Architect's Supplemental Instructions (ASI's)

Project: Ellis Glen
Issue Date: August 22, 2024 (drawing dated August 22, 2024)
ASI No.: ASI- 01

ARCHITECT'S SUPPLEMENTAL INSTRUCTION NO: ASI- 01
CONTRACT FOR: Ellis Glen
ORIGINAL DRAWINGS DATED: 18 March 2024

The following plan changes were requested by the owner and made to the permit documents. These changes shall be incorporated:

ACCESSIBILITY PLANS

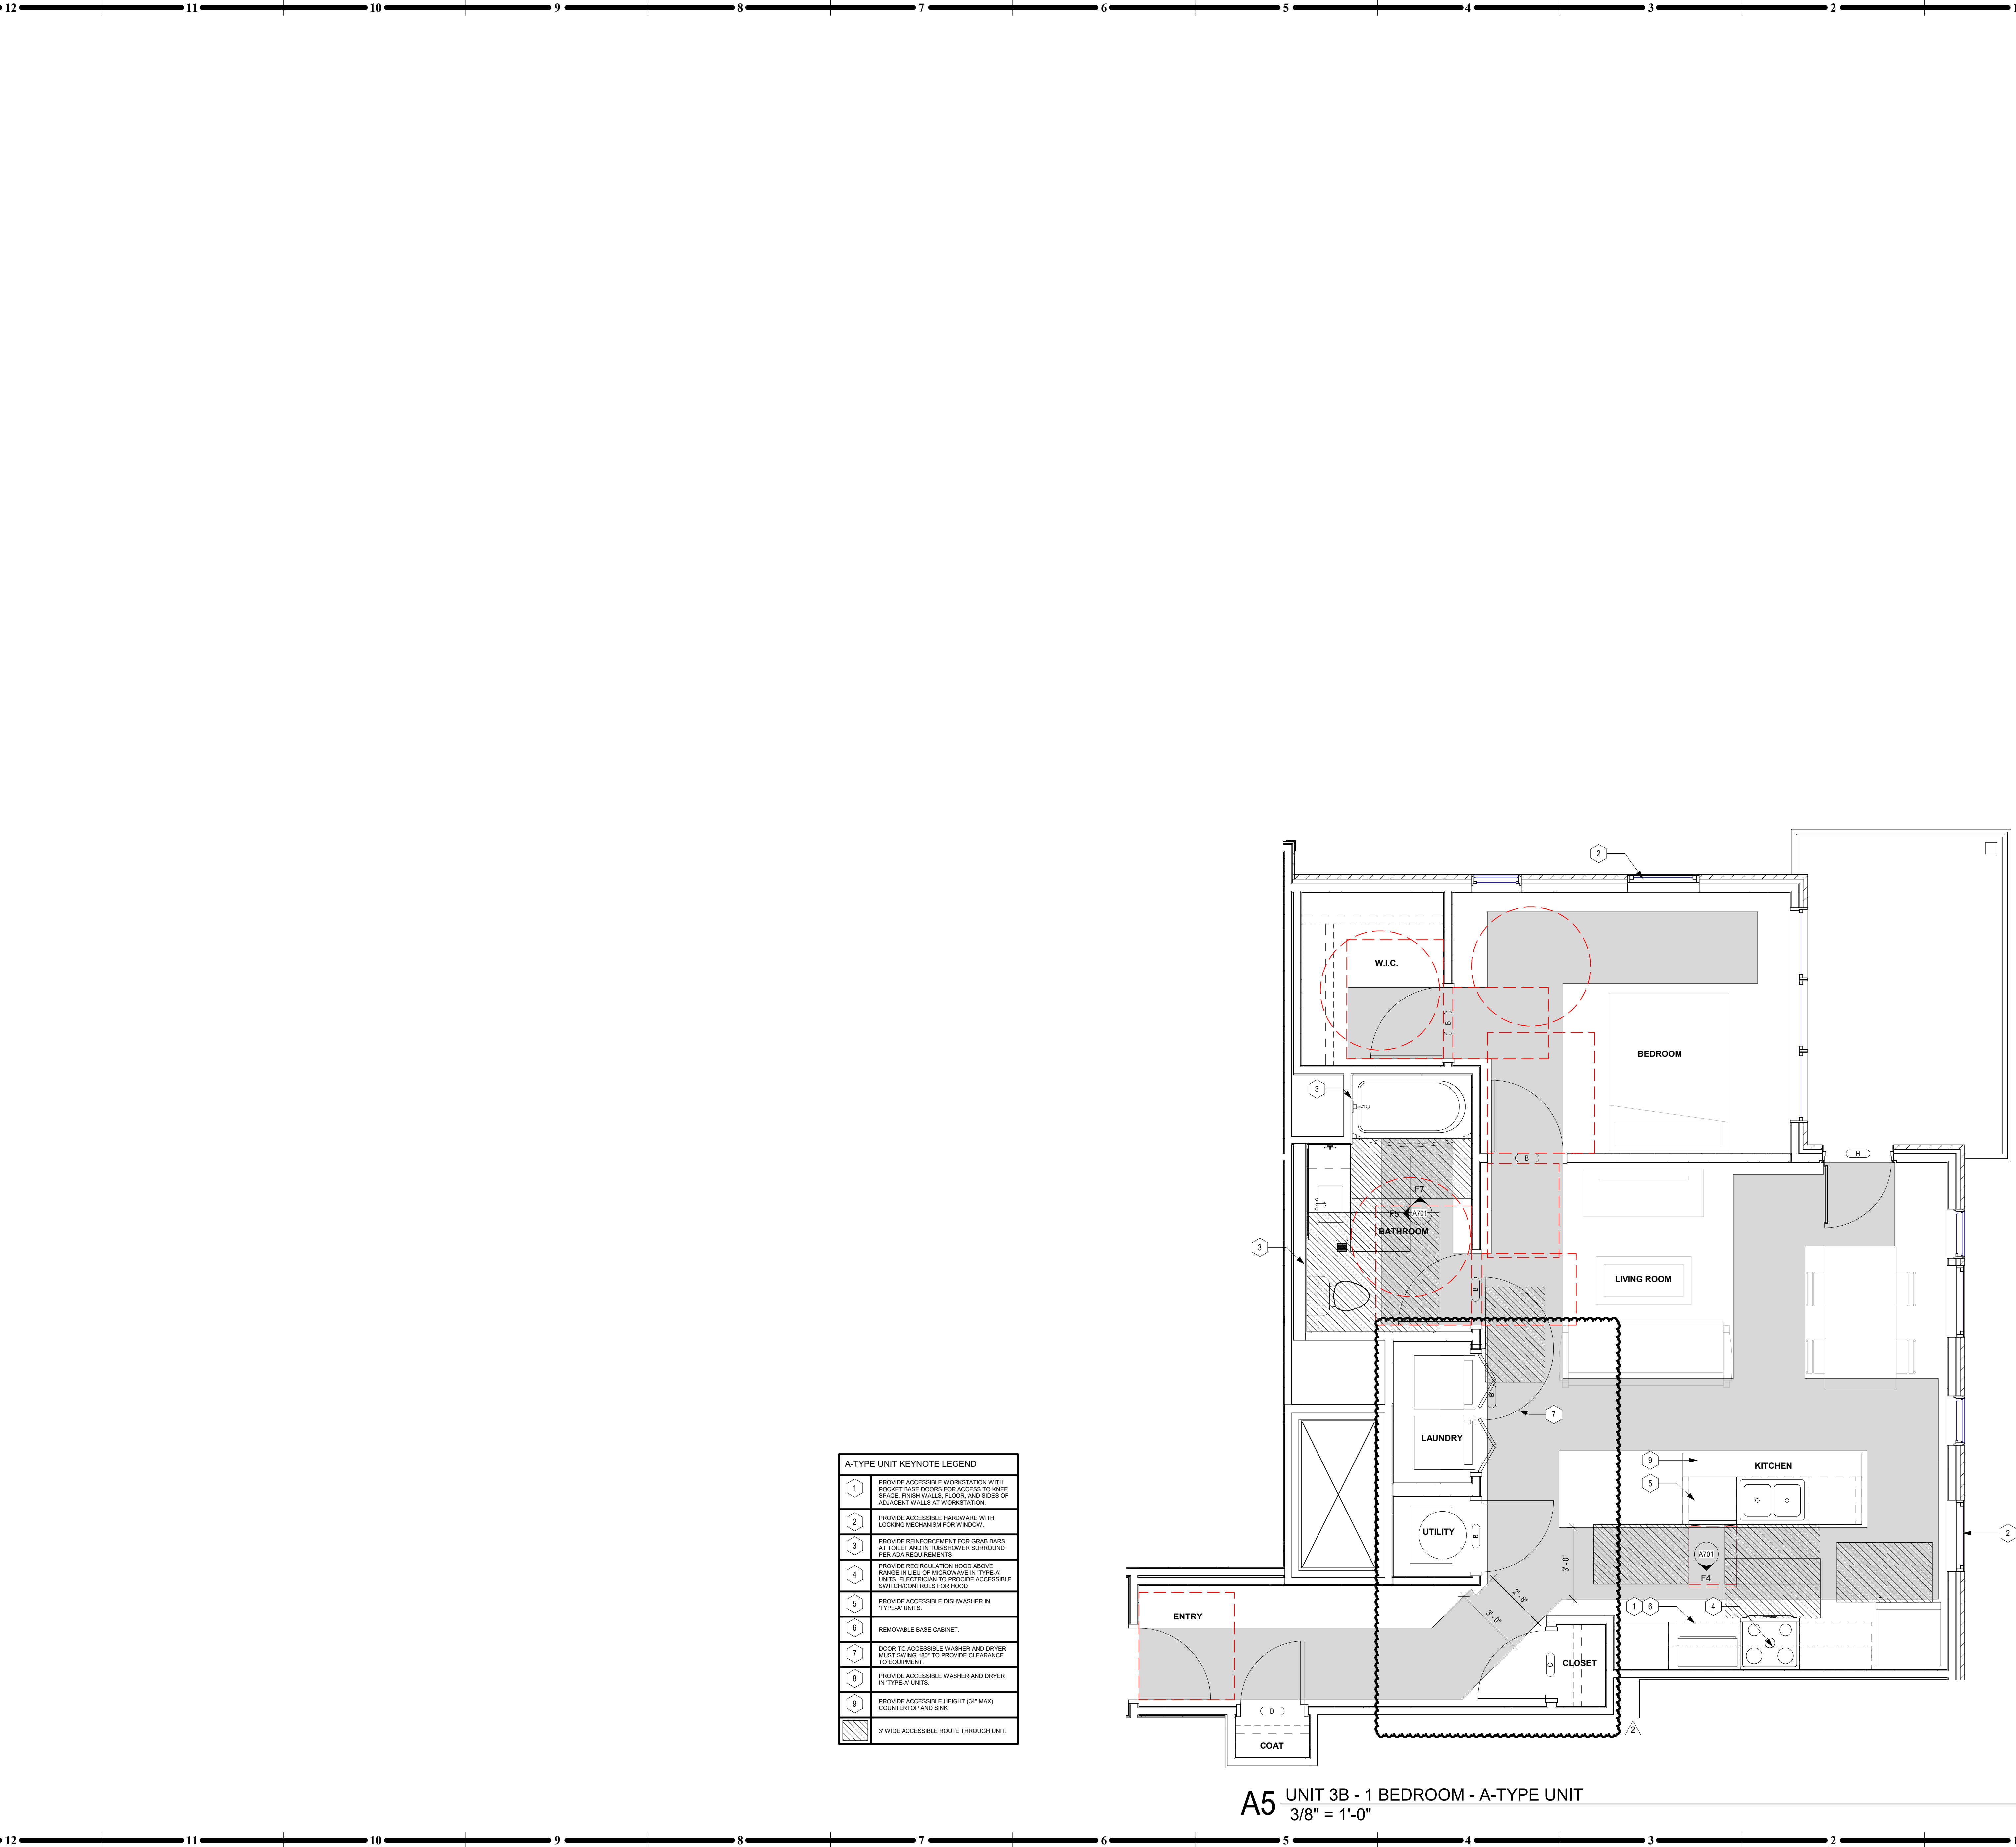
- Missing door tags were added in Unit B3 and C2 on pages A124 and A127.
- Changes were made to Unit B3-A on page A125. The changes include enlarging the washer/dryer closet to allow for a side-by-side washer and dryer. This resulted in needing to shift the mechanical room down to align with the entry wall. The accessible route still works as illustrated on the revised G004 plan.

G004 – Accessibility Plan

1. Accessible route updated to match new unit plan.

FLOOR PLAN - 2ND + 3RD FLOOR

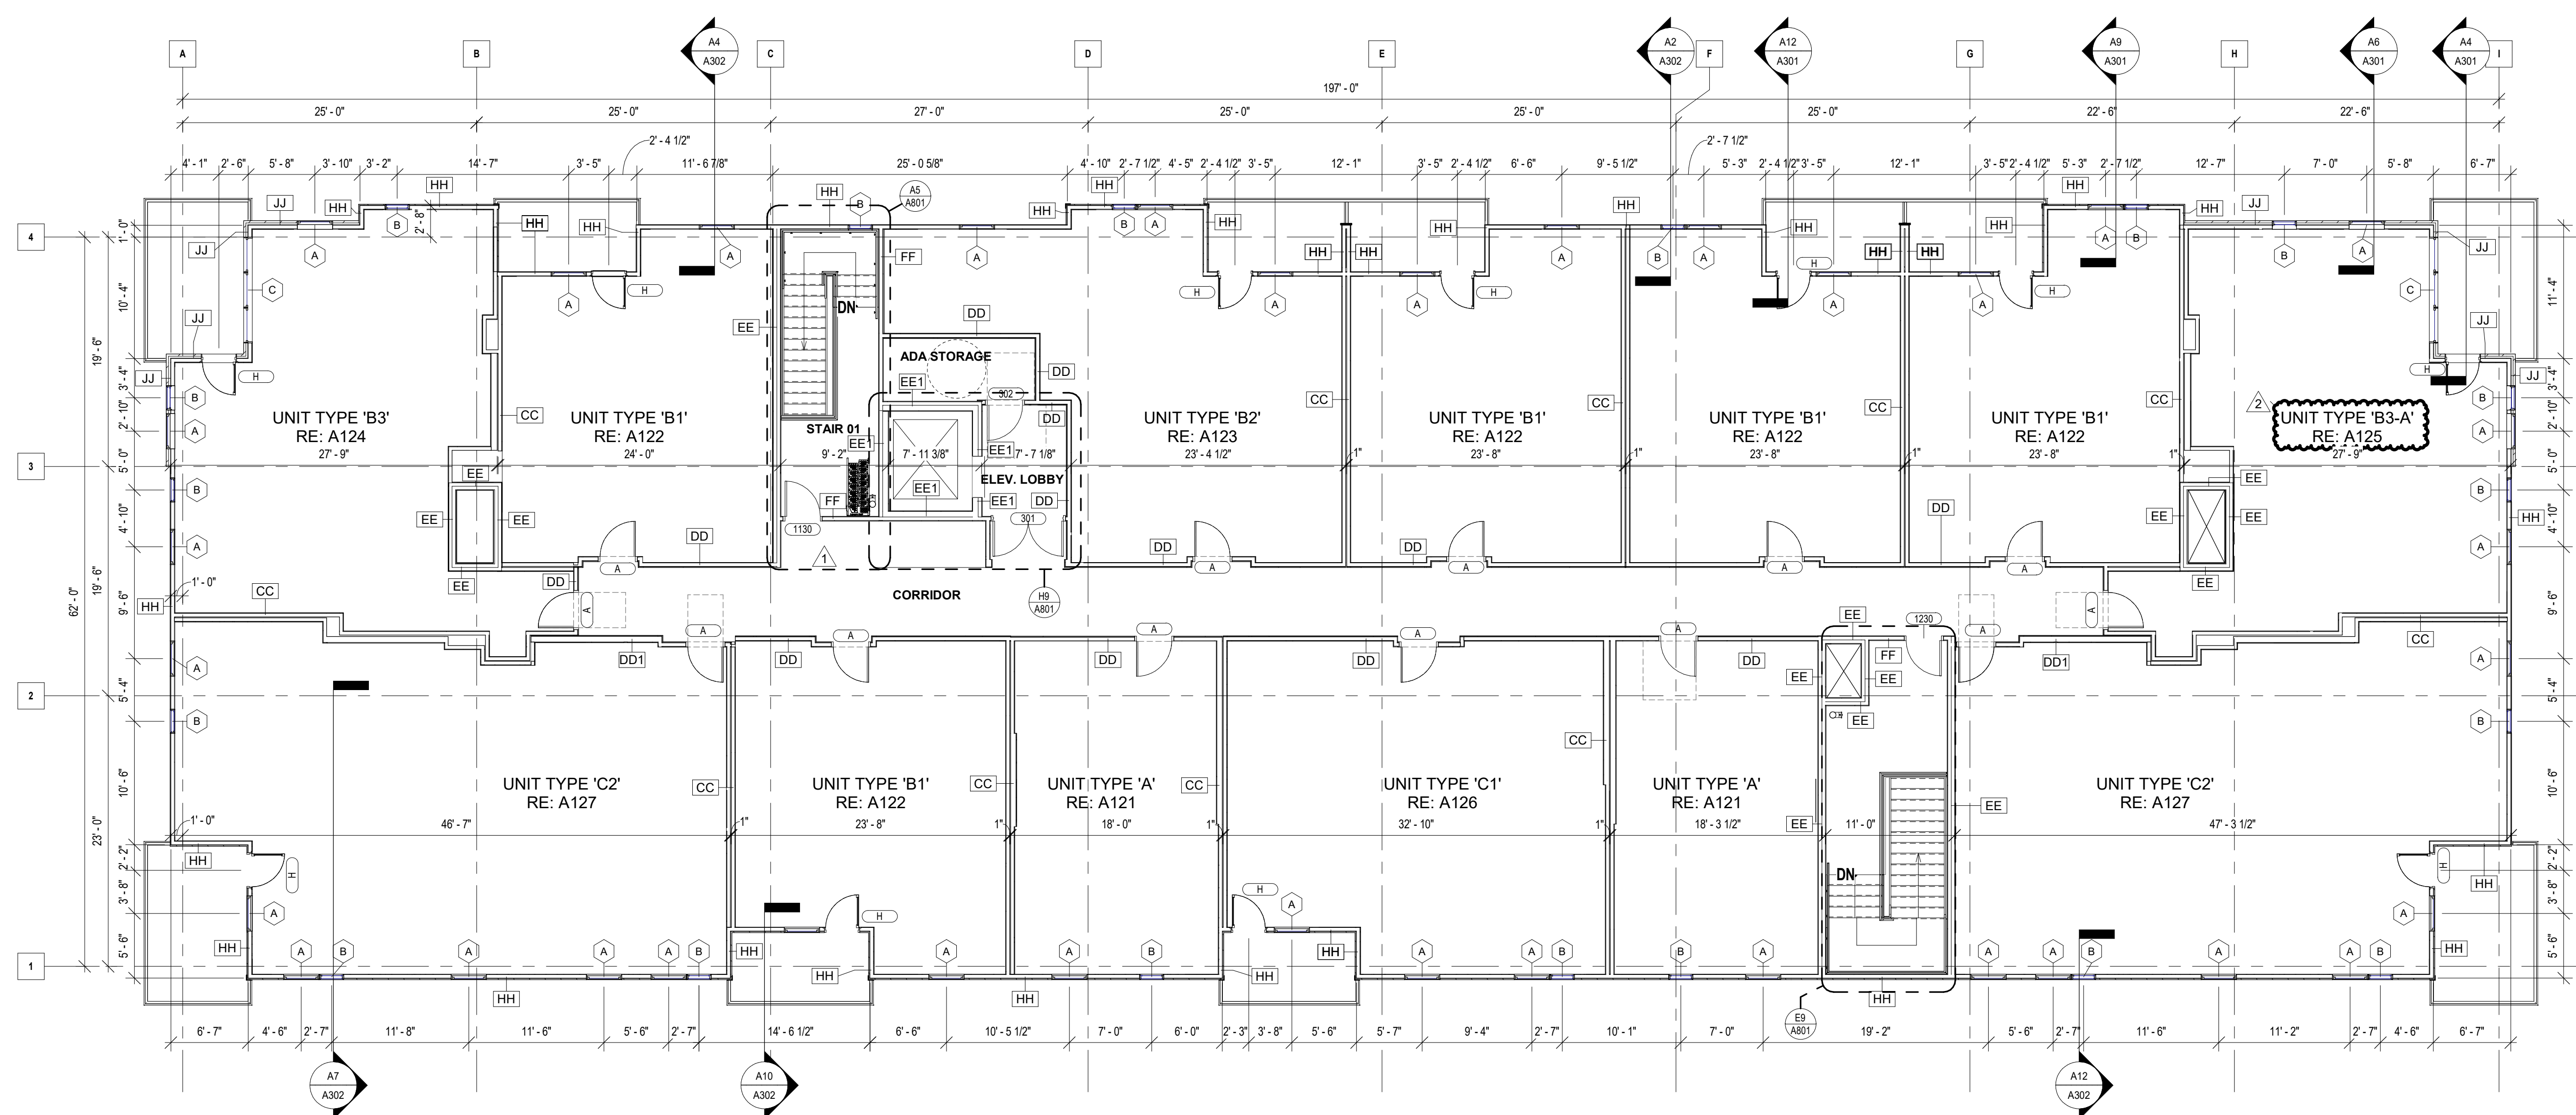
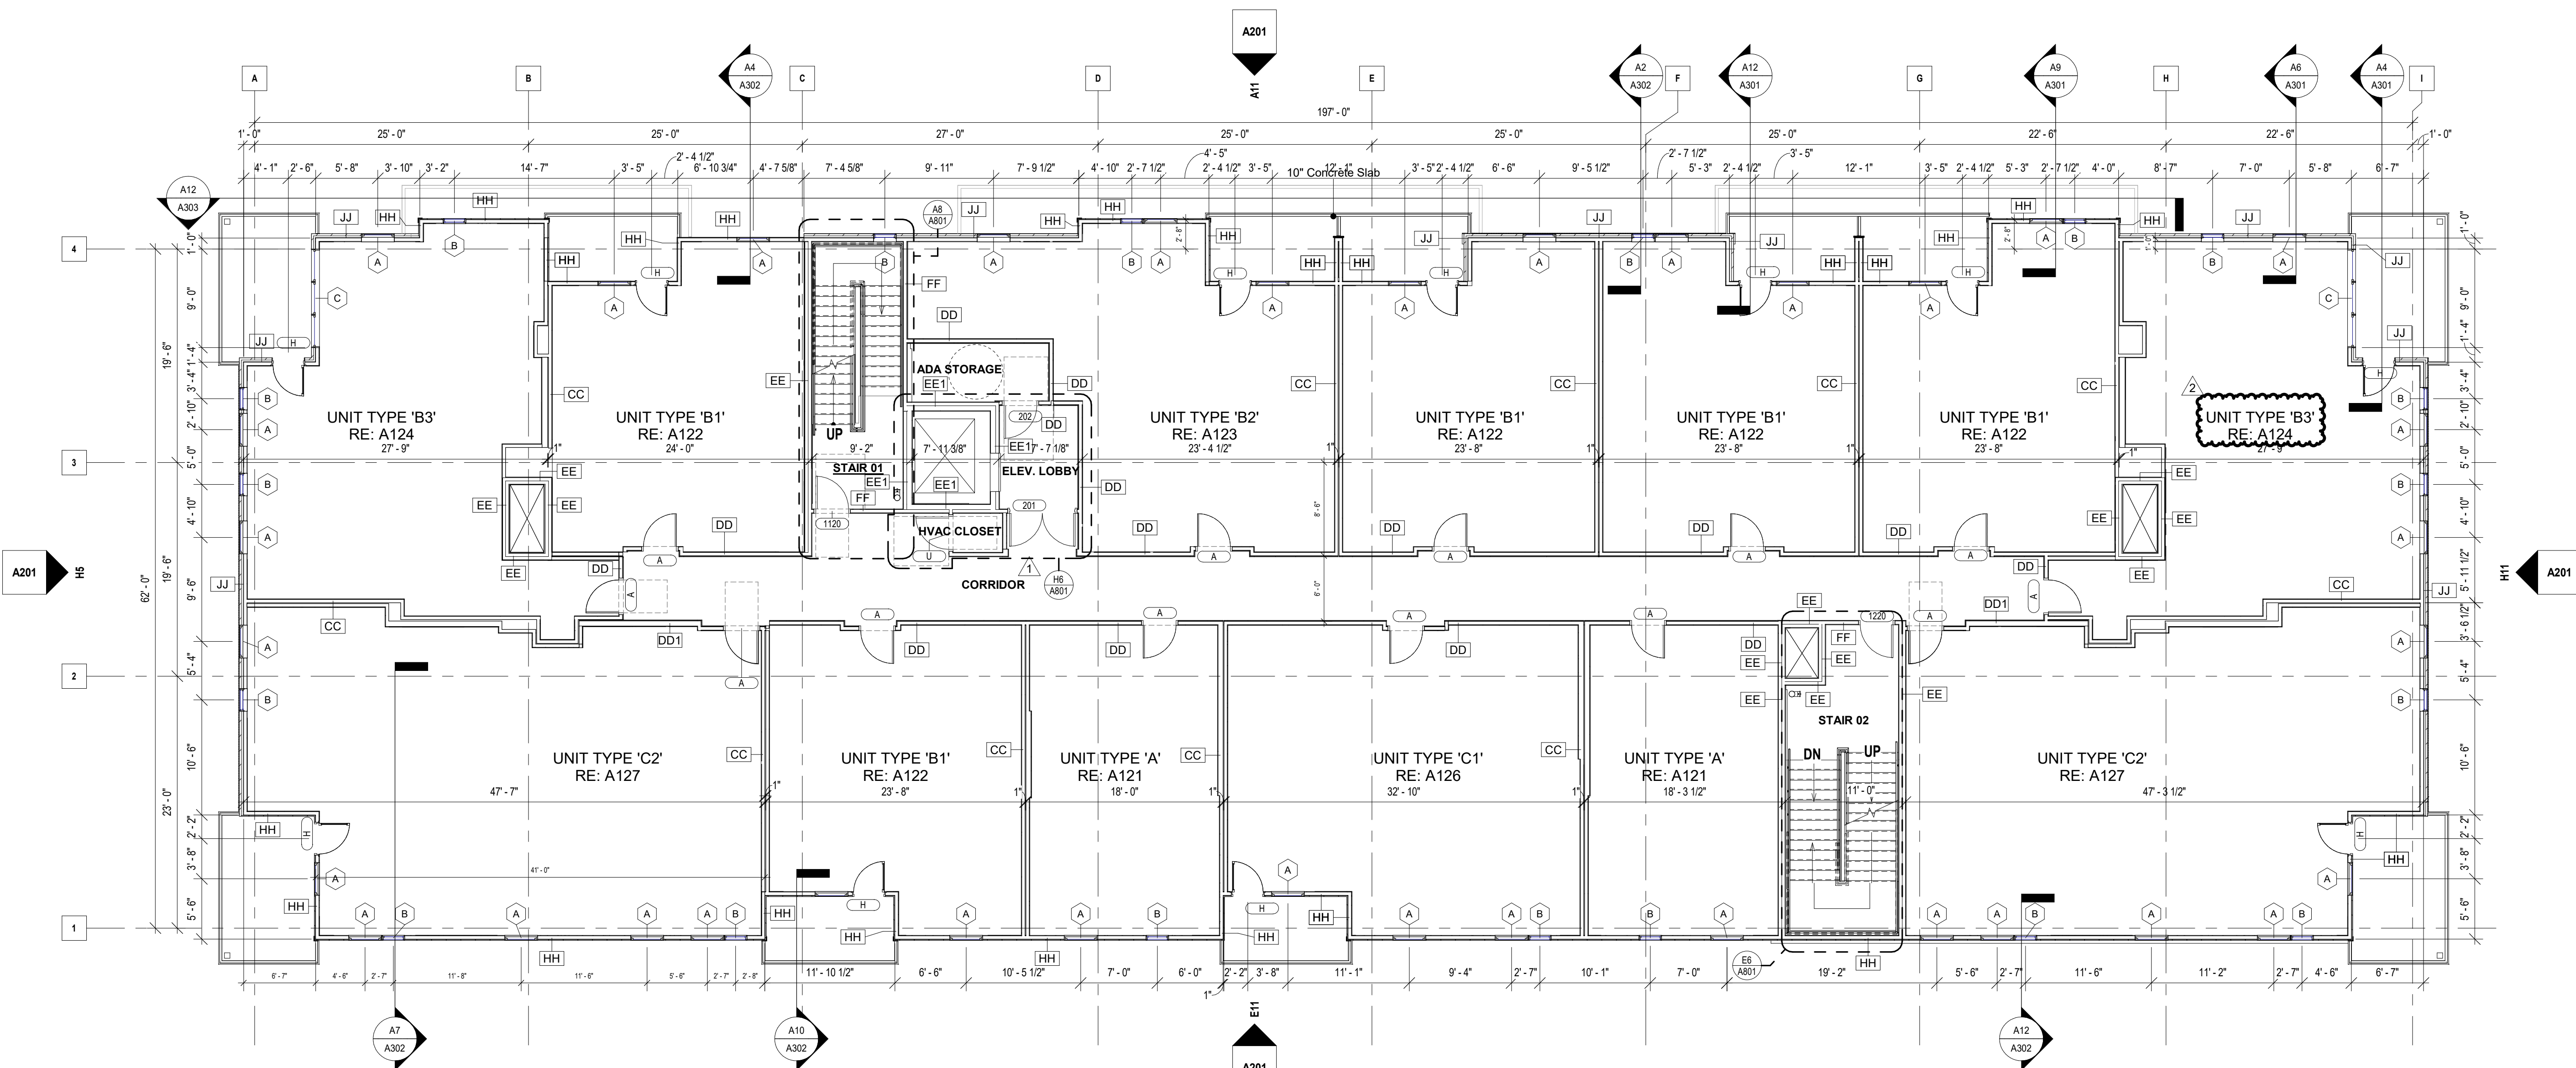
A102 – Floor Plan – 2nd & 3rd

1. Update room tags on both levels to relocate the B3-A unit to the third floor.
